Number	A.1.
Section	General Information
Sheet	1 (of 1)
Date	January, 1960

PRELIMINARY INFORMATION

SERVICE BULLETIN NO.219

VARIOUS SERVICING ITEMS

OIL FILTER AND BLANKING PLATE - MODIFIED TYPE

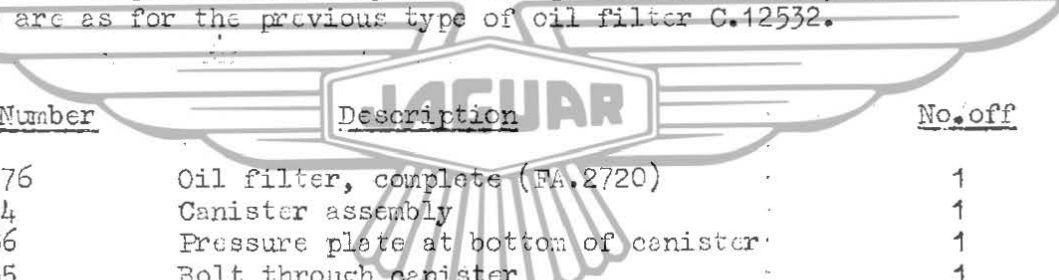
On cars with the above engine numbers and onwards a modified type of oil filter is fitted.

The modified type of oil filter has a dome nut to retain the oil pressure relief valve and has a straight outlet adaptor for the hose to the oil sump whereas the previous type of filter had a banjo connection.

The modified blanking plate has a "dimple" formed in the plate to ensure that it cannot be fitted the wrong way round.

NOTE:- Oil filter C.12776 may be used to replace oil filter C.12532 providing the following parts are also changed:-

Fit C.12803 Blanking plate to replace C.12381
Fit C.13091 Gasket to replace C.12177
Fit C.12861 Hose to replace C.12382
Fit NB.131/15D Bolt to replace C.NB.131/11D

REAR AXLE FOULING BODY

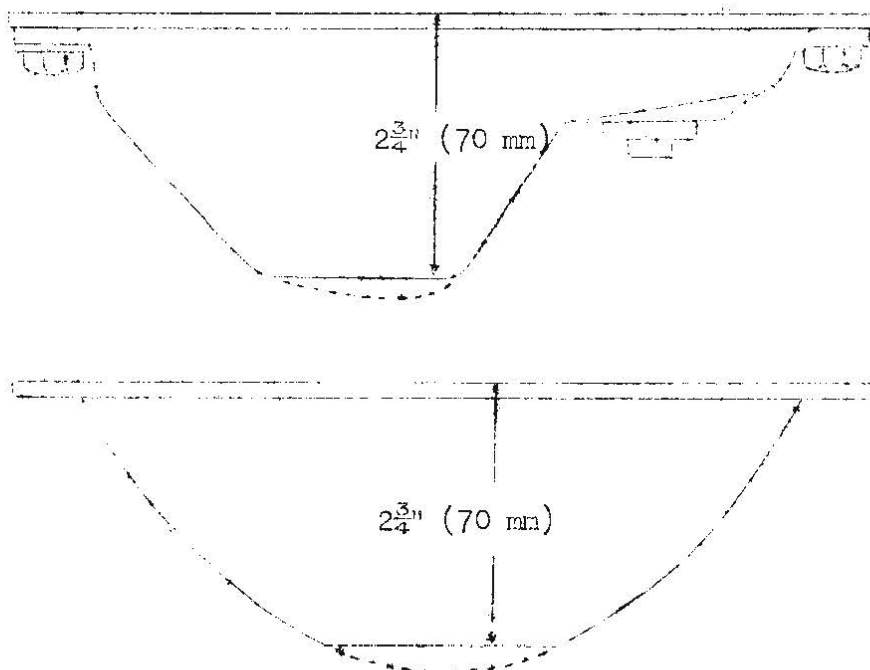
Model affected
3.4 litre.

1. Drain the rear axle.
2. Remove the rear axle cover plate and gasket.
3. Modify the rear cover plate in accordance with following sketch. It will be necessary to locally heat the portion to be flattened and when modified the distance to the flange of the cover plate must not be less than $2\frac{3}{4}$ " (70 mm.)
4. Offer up the rear cover plate to the rear axle case without the gasket, and temporarily secure with four setscrews.
5. Check that no fouling occurs between the rear cover plate and the drive gear, by jacking up both rear wheels and rotating in the same direction. Examine the inside of the cover plate for signs of contact.
6. If satisfactory refit cover plate and gasket and replenish with oil.

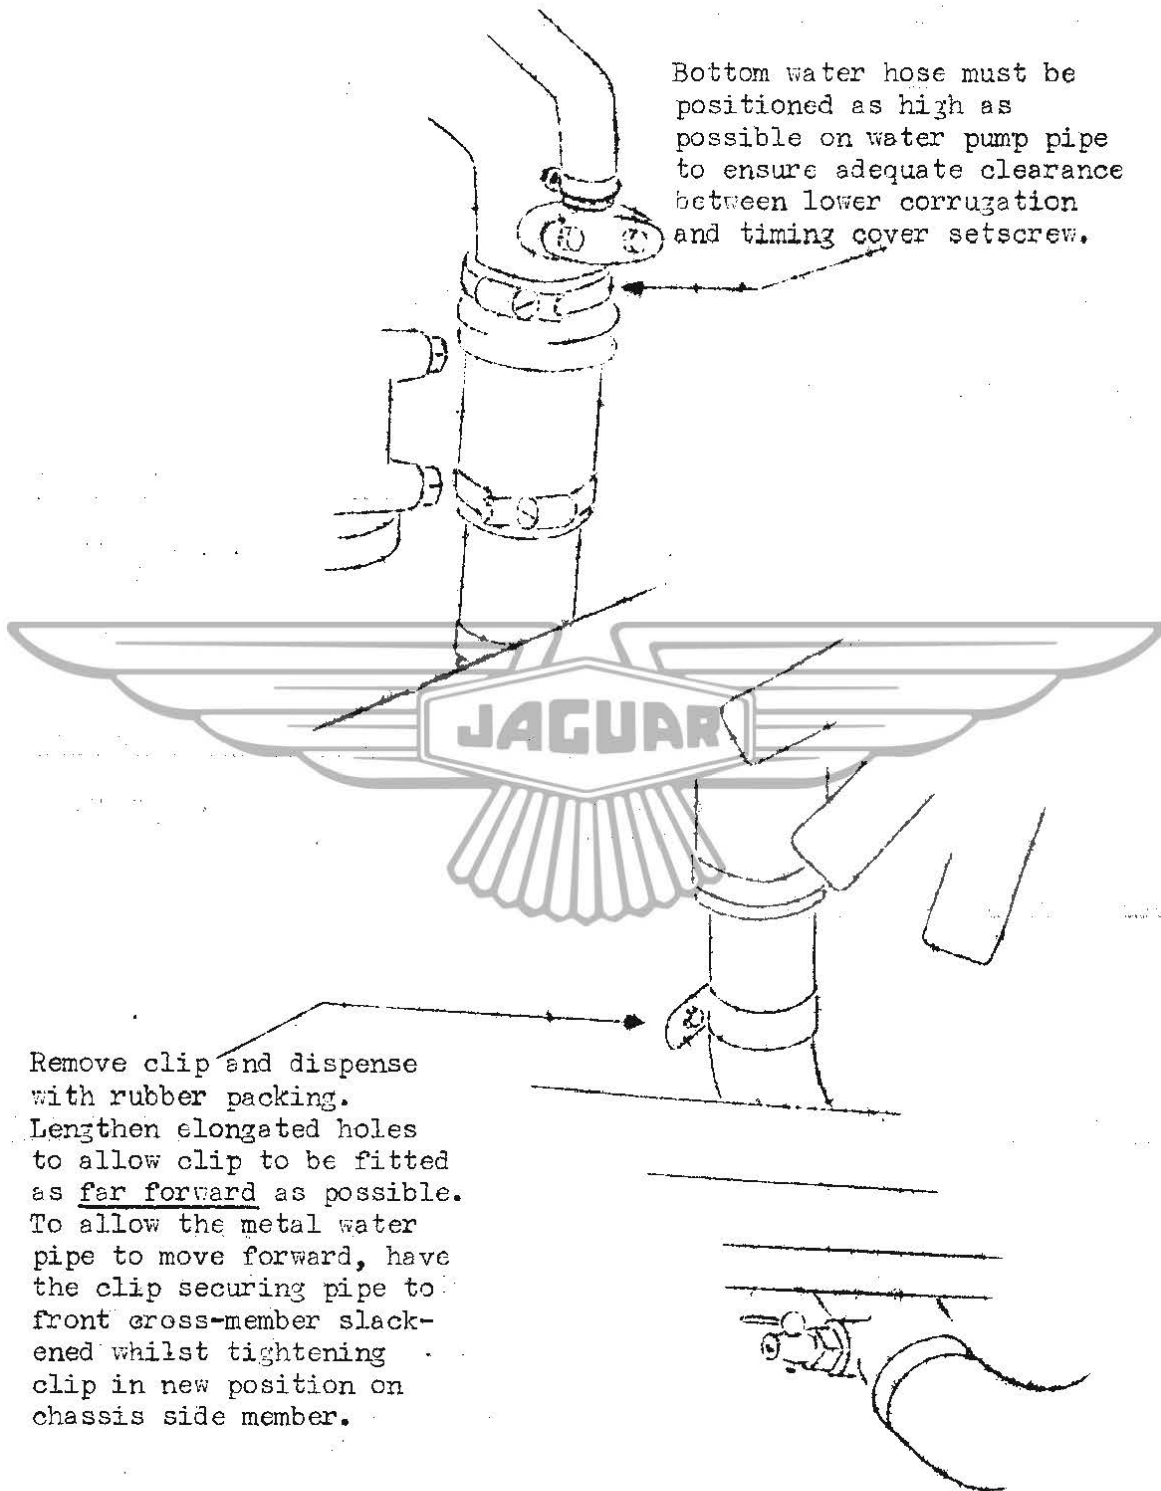
In some instances, on left hand drive cars prior to the above chassis numbers, the water hose between the water pump and the metal pipe may be positioned too close to the timing cover with consequent chafing between the hose and timing cover setscrews.

Distributors and dealers are, therefore, requested to examine all XK.150 cars prior to the above chassis numbers, which come into their premises, for adequate clearance between the hose and timing cover setscrews. If insufficient clearance exists the following rectification procedure should be carried out and if chafing of the hose has occurred a new hose (Part number C.12924) must be fitted.

Remove clip and dispense with rubber packing.
Lengthen elongated holes to allow clip to be fitted as far forward as possible.
To allow the metal water pipe to move forward, have the clip securing pipe to front cross-member slackened whilst tightening clip in new position on chassis side member.

PROCEDURE TO OVERCOME HANDBRAKE COMPENSATOR FOULING BODY

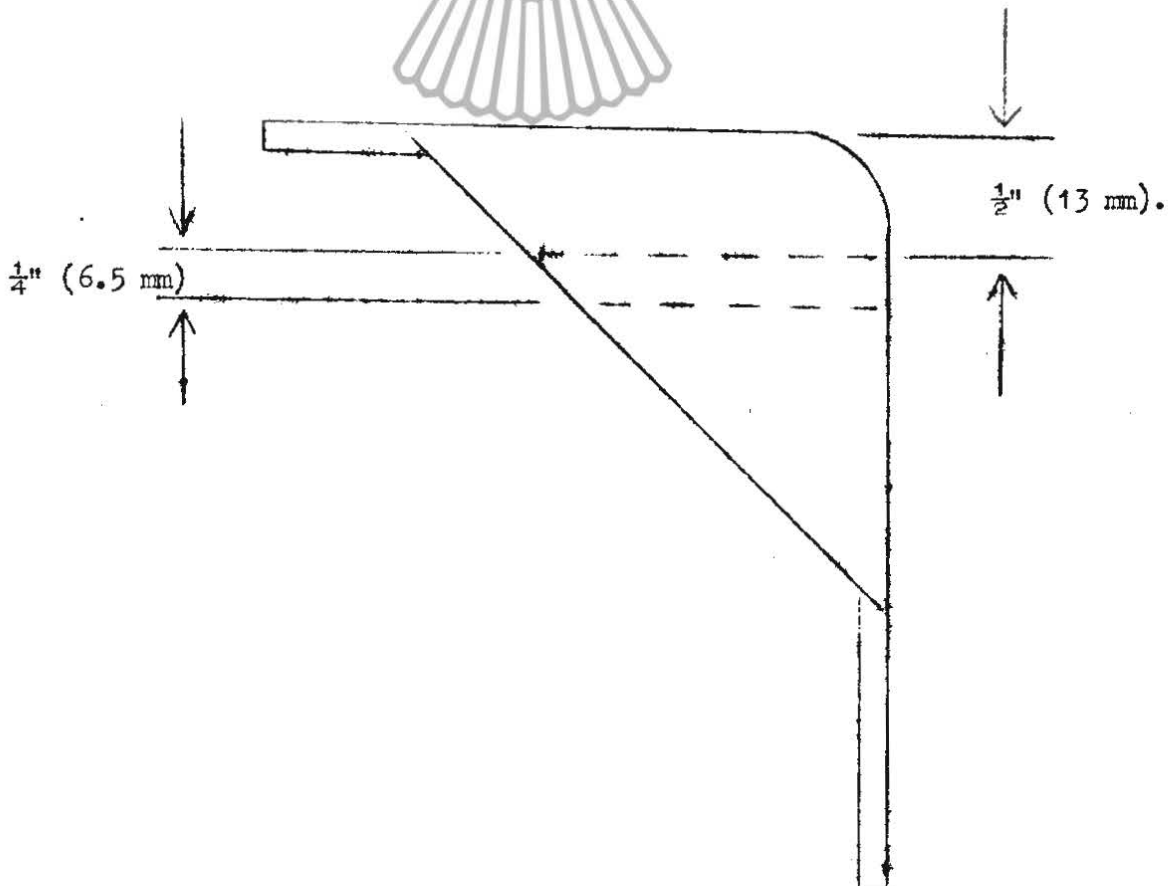
Under full bump conditions there is a possibility that the handbrake compensator fitted to the rear axle may foul the bottom of the luggage boot floor giving rise to a knock from the rear of the car.

1. Remove the handbrake compensator bracket which is secured by two of the rear axle cover screws.
2. With a hacksaw cut out a $\frac{1}{4}$ " (6 mm) strip of metal to reduce the effective height of the bracket. Weld the two halves of the bracket together. (see sketch).

Check 1.

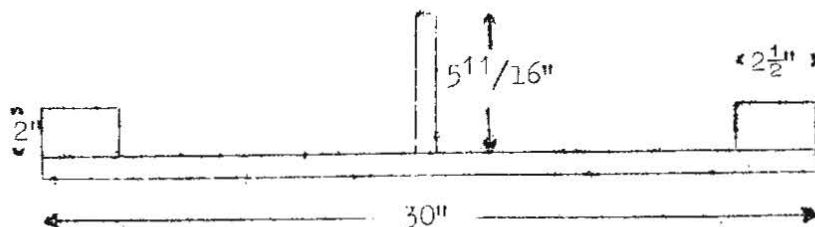
Check the distance from the bottom of the front flange of the front propeller shaft to the bottom faces of the longitudinal chassis side members. This distance should be $3.11/16" \pm 1/16"$ ($93.5 \text{ mm} \pm 1.5 \text{ mm}$). A simple checking jig can be made for checking this distance as shown in the following sketch.

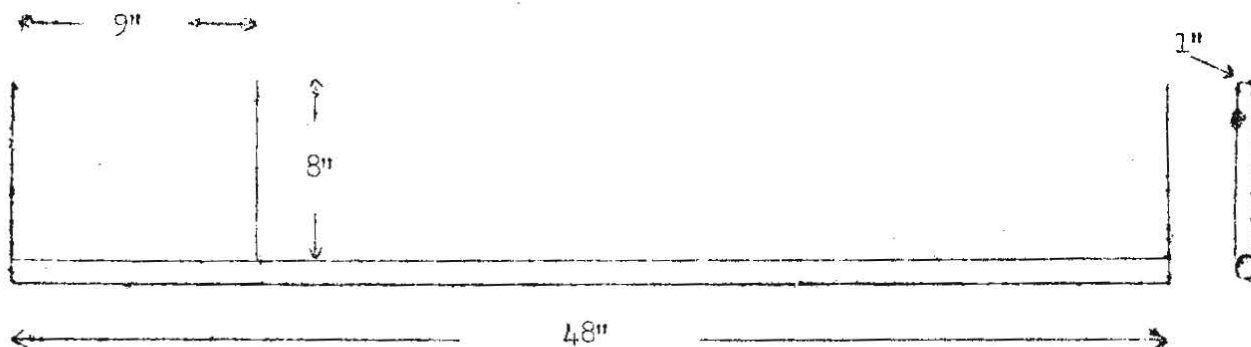
Check that the front and rear propeller shafts are in a straight line in the horizontal plane.

The most convenient way to do this is to make up a simple jig as shown in the following sketch. The jig consists of 3 pieces of flat bar 8" x 1" x 3/16" (20.5 cm x 2.5 cm x 4.75 mm) which are welded exactly in line on to a piece of tube of 1 1/8" (28.5 mm) outer diameter at the distances shown in the sketch. The jig is then held against the front and rear propeller shafts, with the three bars vertical, when any malalignment will be evident.

An alternative method is to use three plumb bobs and sight along the three cords. Two cords should be positioned at the front and rear of the front propeller shaft tube and the remaining cord at the rear end of the rear propeller shaft tube.

MODIFICATION TO WHEEL ARCH.

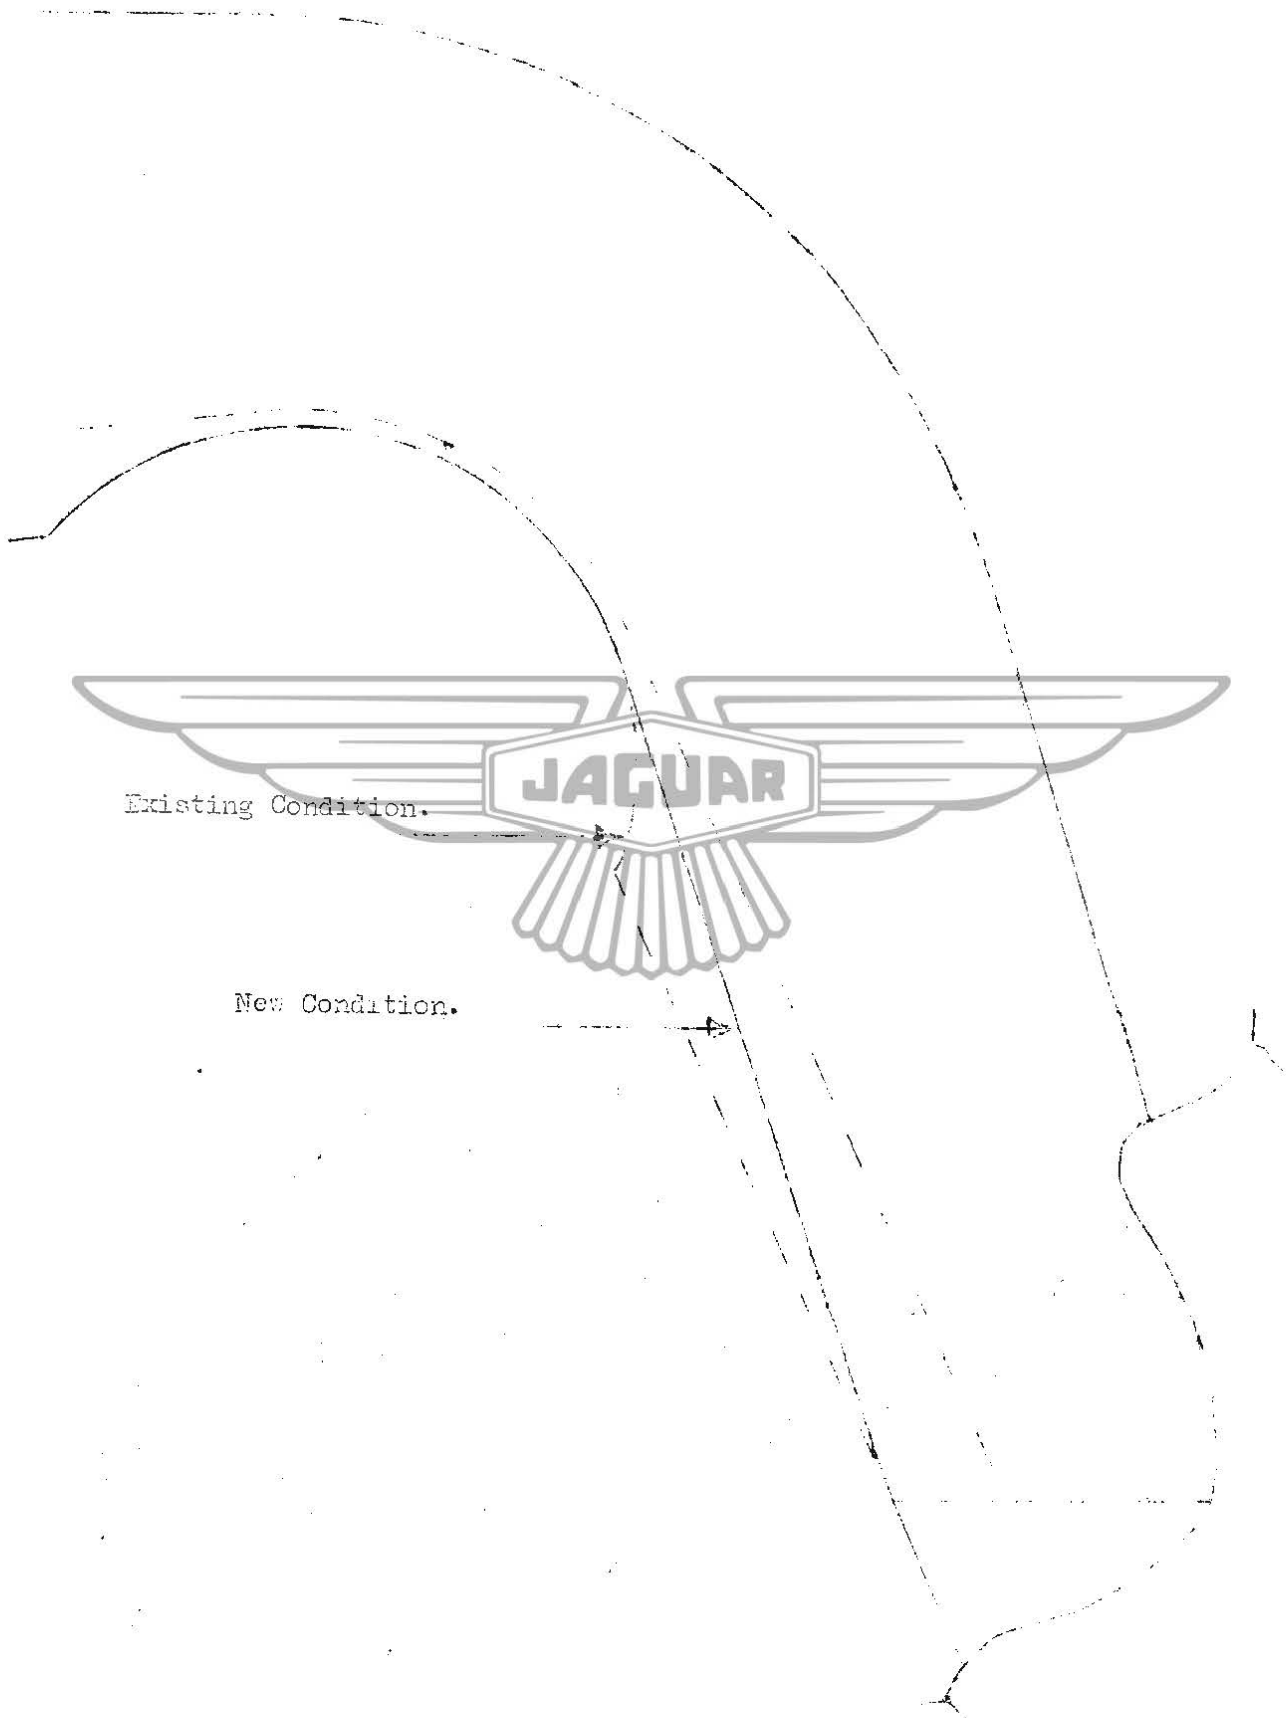
Note: It is IMPORTANT to carry out the above two body modifications otherwise fouling will take place between the handbrake compensator and trunk floor, and also between the handbrake cross cables and the wheel arches.

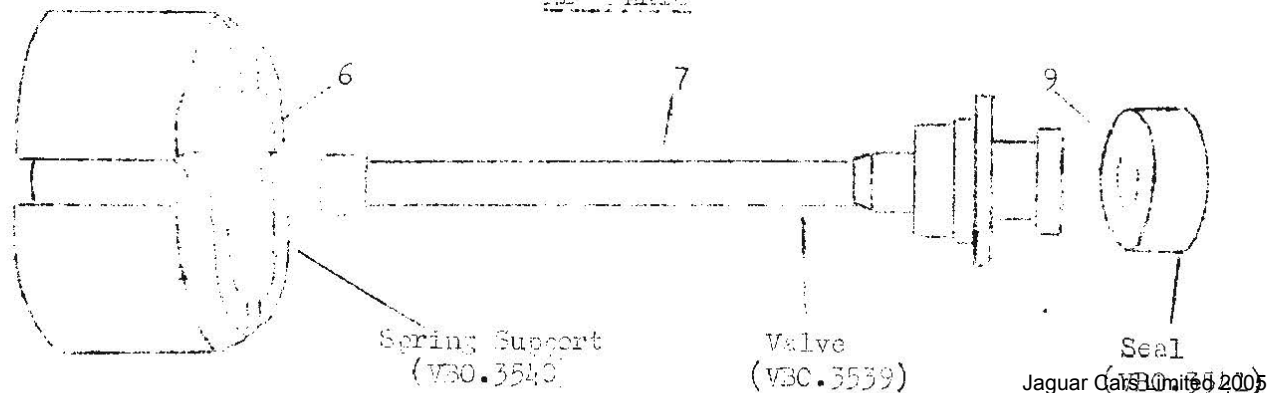
Note: A separate bush for the seal is no longer used. The drawings on the next page show the difference between the old and the new parts. The differences between the old and new parts are easily recognisable except in the case of the spring supports between which there is no visible difference. The old type spring support must not, in any instance, be refitted.

- (6) Using the new components (6), (7) and (9) shown in the sketch below reassemble items (4) to (9) inclusive in the order shown and retain them by engaging the valve (7) in the central bore of the spring support (5). **NOTE:** The old and new spring supports item (6) are almost identical in appearance but it is essential that only the new support is used for this modification.

Procedure.

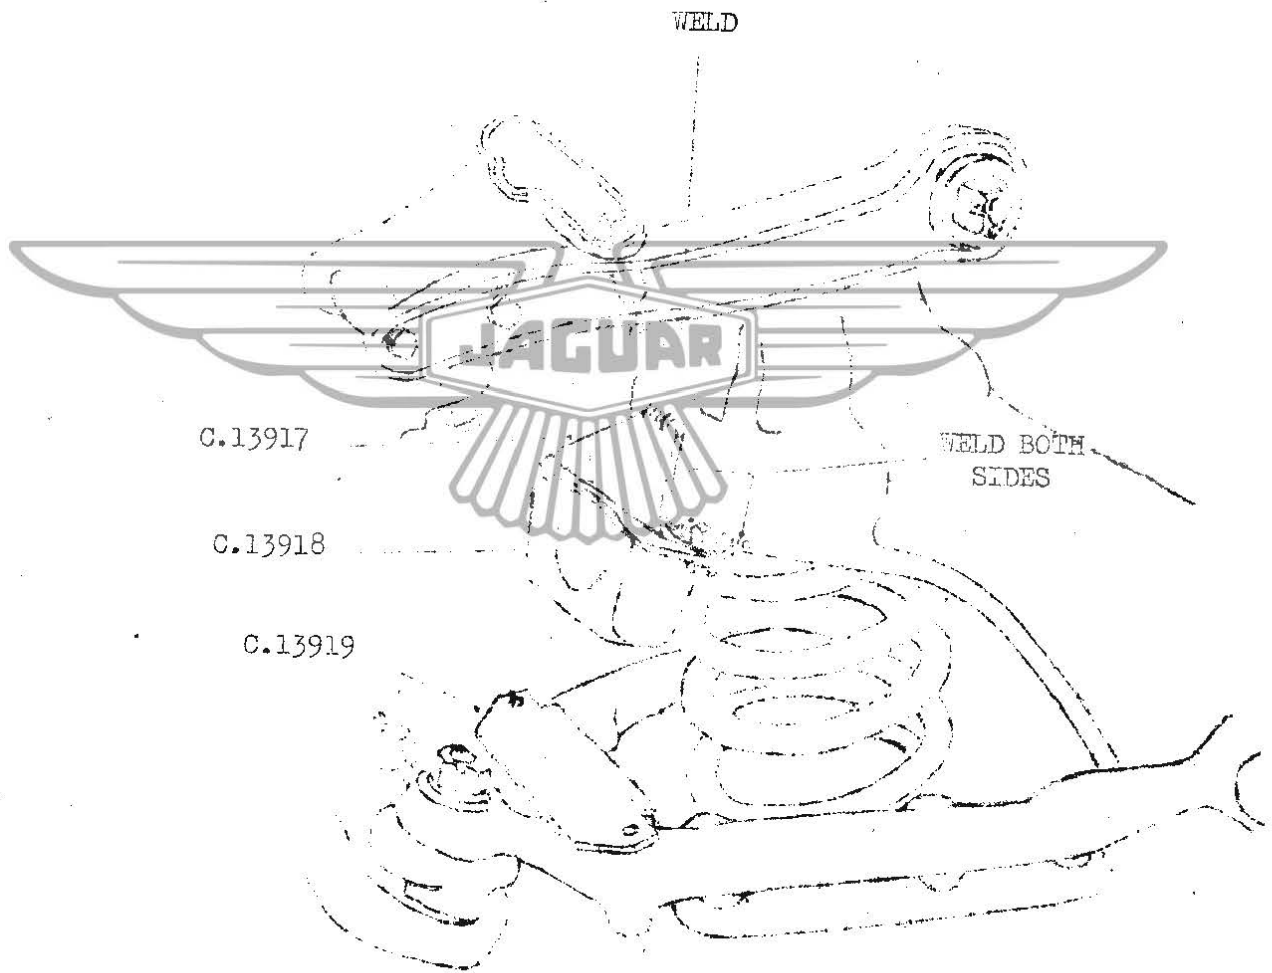
The progressive type of bump stop can be fitted in place of the previous arrangement if desired, but should only be carried out at the customers request and will be on a chargeable basis except in special circumstances.

The necessary welding should preferably take place with arc welding equipment but if this is not available and gas welding equipment is used, suitable asbestos or metal shields should be placed around the front suspension coil springs to protect them from the flame.

Jack up the car, remove the front wheels and place supports under the chassis side members. Jack up under the lower mounting of the shock absorber. Disconnect the top ball joint from the upper wishbone levers taking care not to lose or transpose the castor shims. Allow the stub axle carrier to fall outwards but do not permit the brake flexible hoses to become stretched.

1. Remove the bump stop cups from the flange at the bottom of the front suspension cross member turret. File the underside face of the flange flat and smooth. Clear the two holes already drilled in the flange.

2. Offer up the bump rubber bracket C.13917 to the front suspension cross member turret. To provide an accurate location two dimples or holes are formed in the bracket, which should register with the two holes drilled in the turret flange.

5. Remove the two existing bump stop rubbers from the lower wishbone levers. Cut a 45° chamfer at the top of the holes from which the bump rubbers were removed.
